# PT-19

SPORT SCALE .46/EP ARF

## MANUAL ADDENDUM

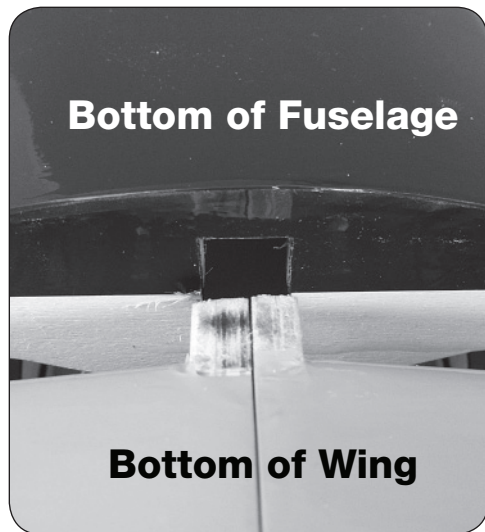
Before starting on **Step 5 on Page 7** of the manual, it may be necessary to test fit the front wing tabs into the former.

If the tabs are too wide for the opening in the former as shown above it will be necessary to remove material from the wider of the two wing tabs.

For removal of a small amount of material from the tab sanding is recommended.

For removal of a larger thickness of material a #11 blade can be used. **CAUTION:** Be careful not to cut through too much material. Sanding is recommended to finish removing material from the tabs.

Test fit the tabs into the former. If proper fit is achieved, proceed with **Step 5**.
